SCENIC TECHNOLOGIES

3-4-10.12

REVIEW NAME: ECTS-SCENIC TECHNOLOGIES SITE PLAN
PROJECT LOCATION: TEMPLE HILL (FREEDOM) ROAD (ROUTE 300)
SECTION 3-BLOCK 4-LOT 10.12
PROJECT NUMBER: 95-12
DATE: 25 SEPTEMBER 1996
DESCRIPTION: THE APPLICATION INVOLVES A PROPOSED CHANGE IN
OCCUPANCY FOR THE FORMER BOSS GLASS BUILDING,
AS WELL AS A PROPOSED NEW BUILDING AND VARIOUS
SITE IMPROVEMENTS. THE PLAN WAS PREVIOUSLY
REVIEWED AT THE 22 MARCH 1995, 26 JULY 1995 AND 10
APRIL 1996 PLANNING BOARD MEETINGS.

TOWN OF NEW WINDSOR
PLANNING BOARD
DRAINAGE REVIEW COMMENTS

Project no. 95003
Revision no. 6
Drawing no. C1

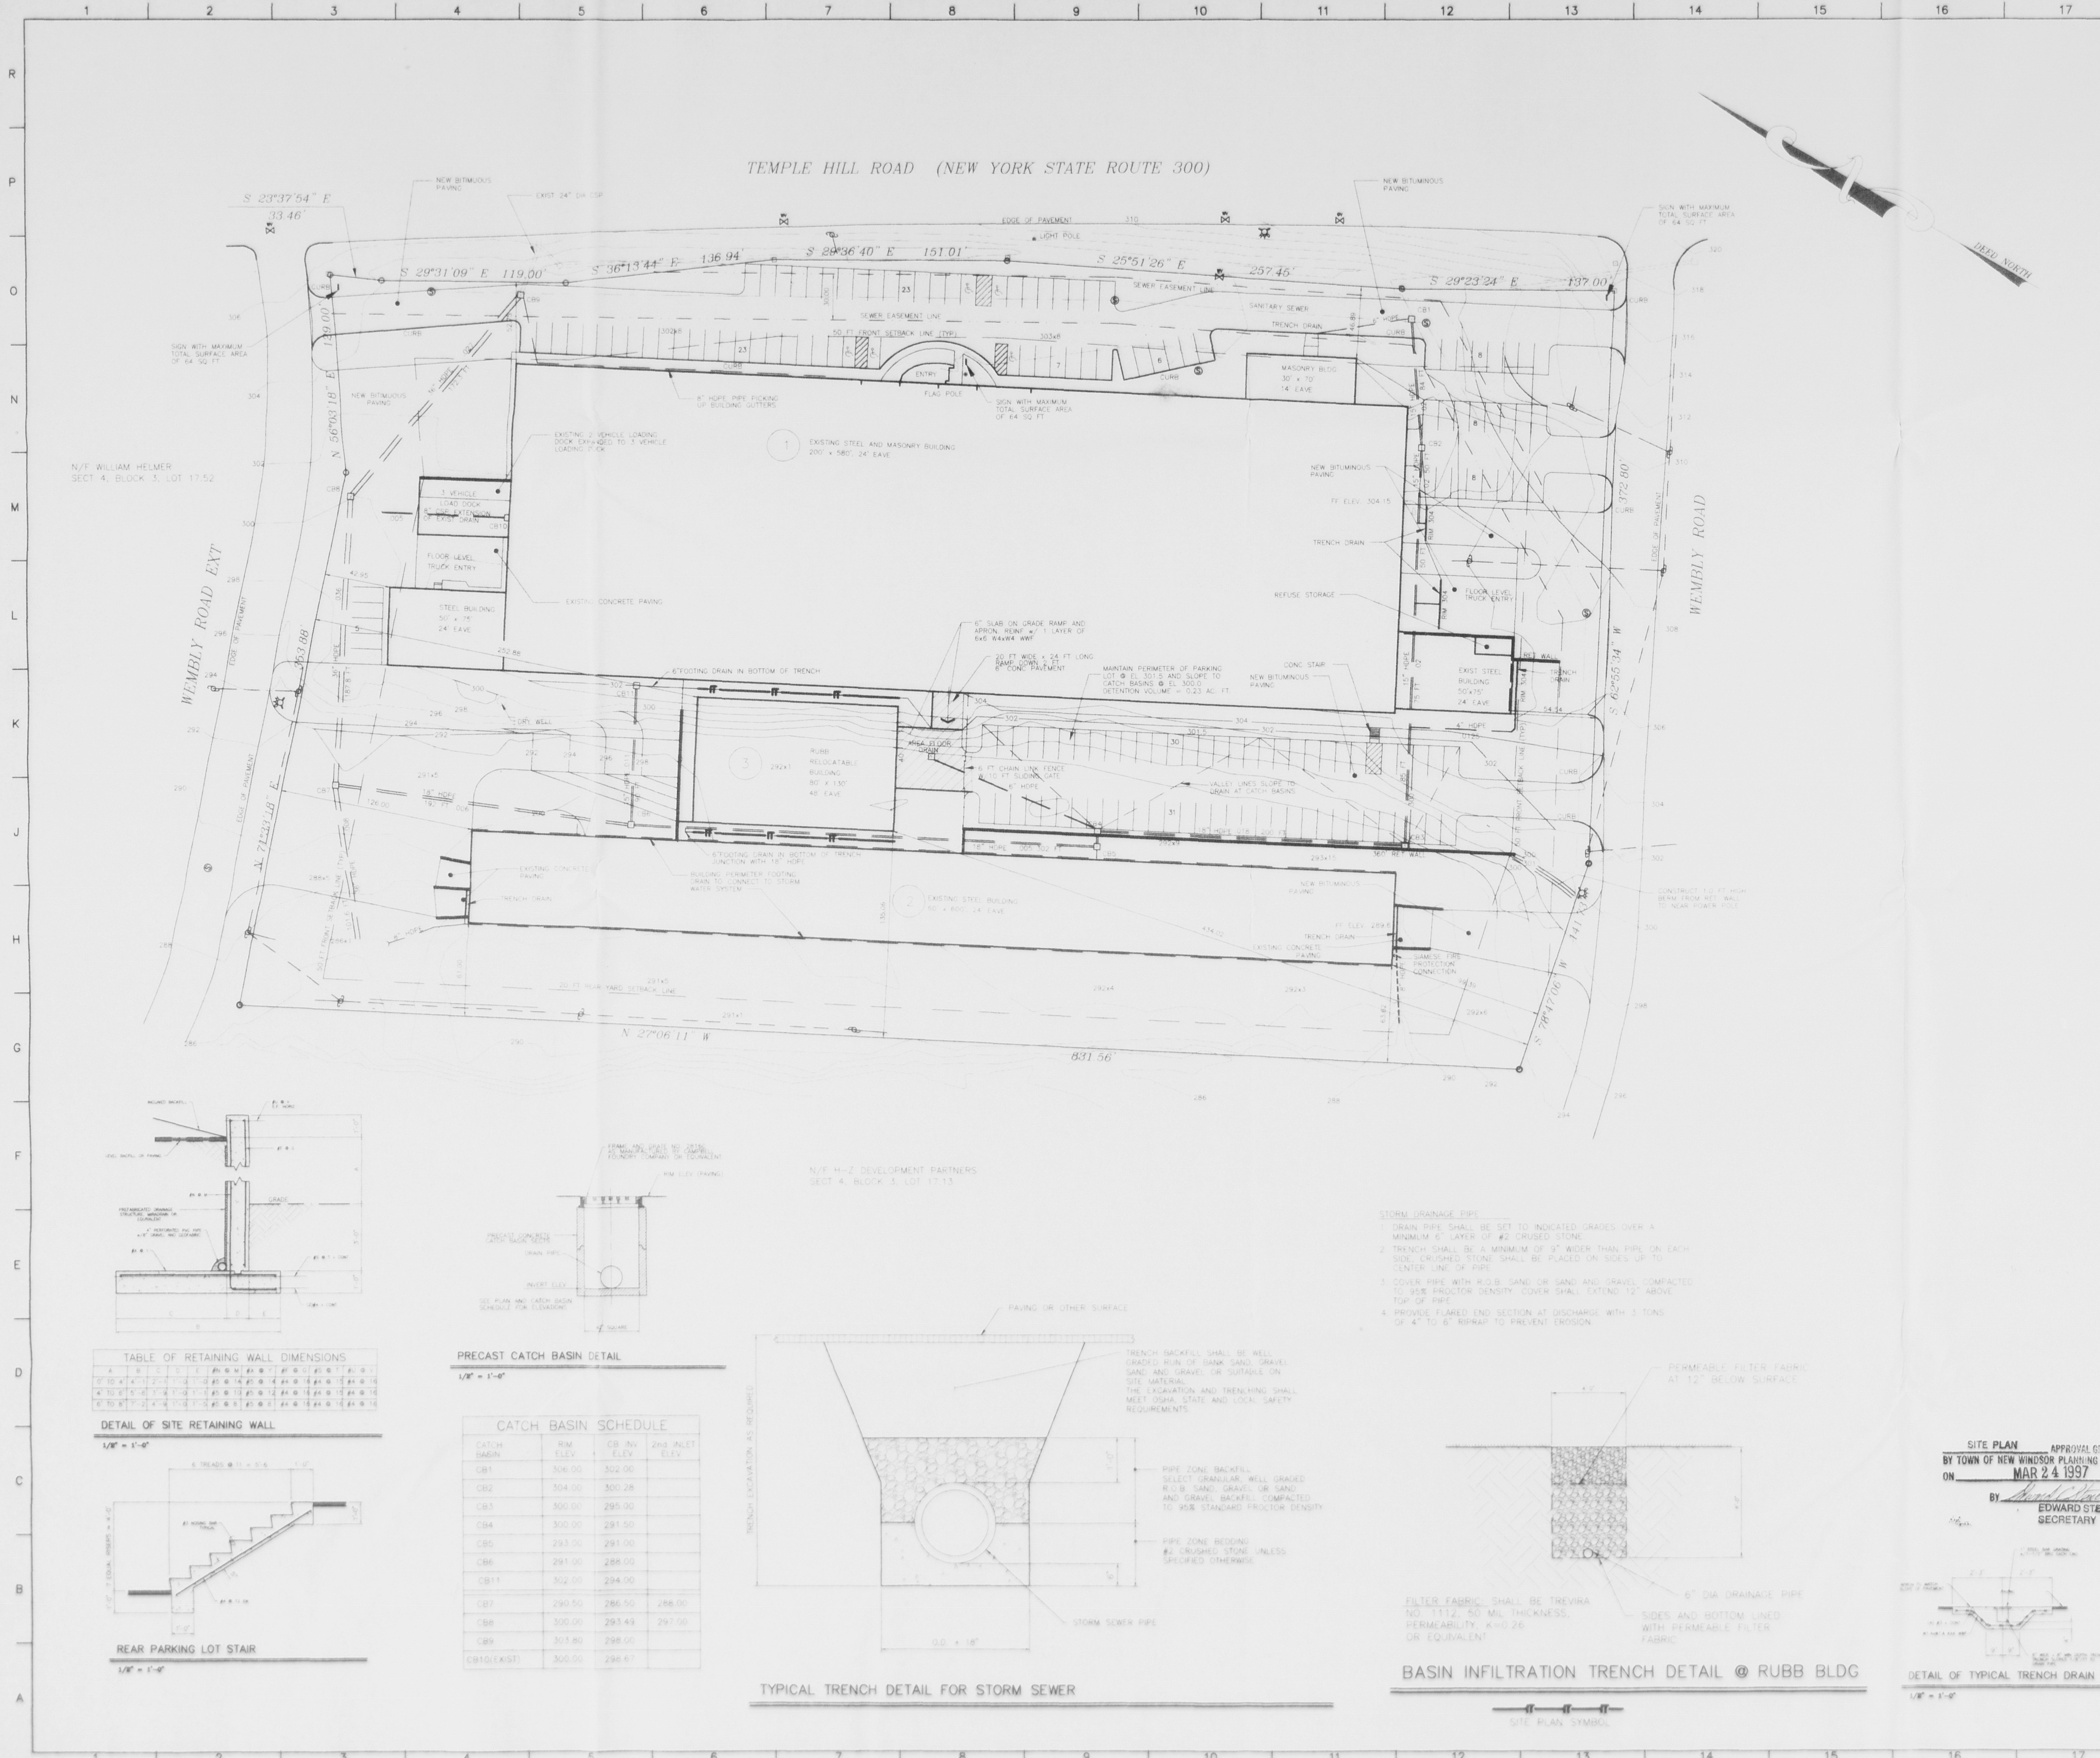
- 2.f. The latest version of Sheet C1 indicates some drainage improvements on the site. We have also received a computer printout of an analysis for the drainage.

Designed by	WCS	Project no.	95003
Drawn by	WCS	revision no.	1
Checked by	WCS	drawing no.	C2
Scale	1"=40'		
Date	9/13/96

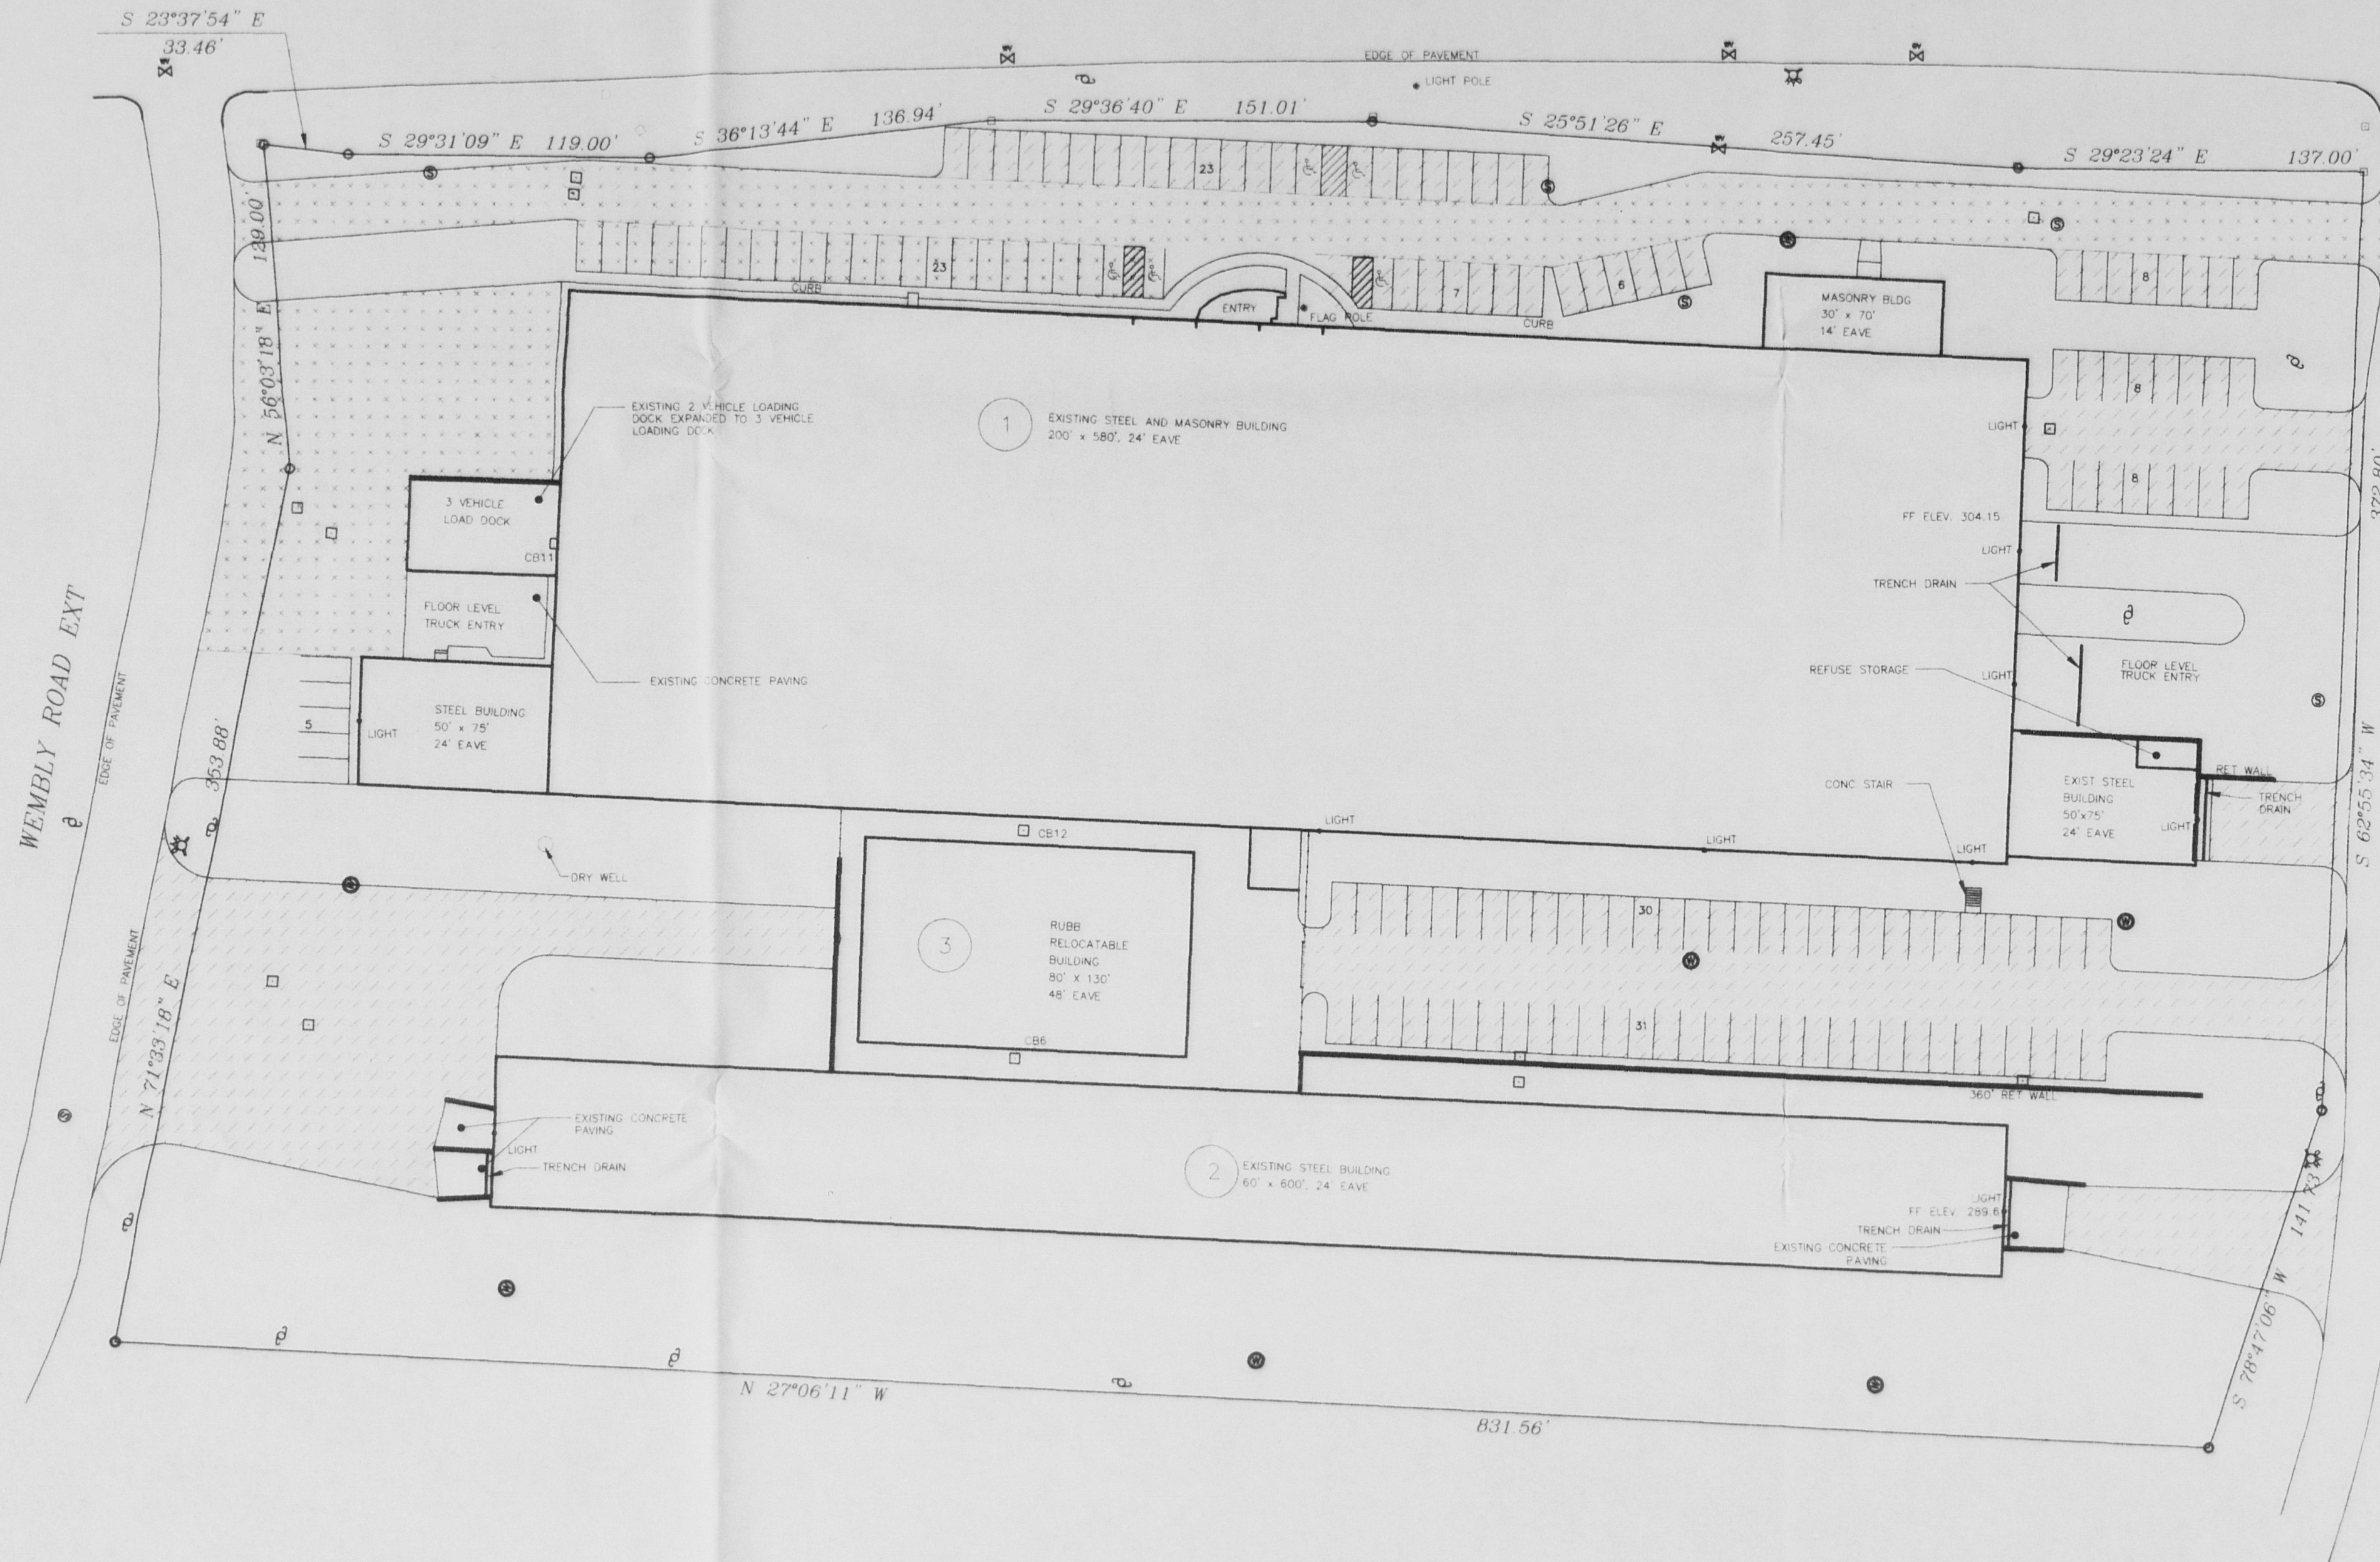
- 2.c. The latest version of Sheet C-2 appears to include some indication of site grading via proposed contours. We are having great difficulty in completely understanding the proposed grading, since the existing contour symbols and proposed contour symbols are difficult to distinguish from other lines on the plan. Further, we are having difficulty in "closing" the contours across the site between proposed and existing conditions.

- b. Although a paving detail has been added to Sheet C-2 of the plans, I question whether all areas will receive 5" of paving. Further, the detail indicates a 6" Item 4 base. Is this required in all areas? Also with regard to the paving detail, I do not recommend the use of crushed stone; this reference should be deleted from the detail.
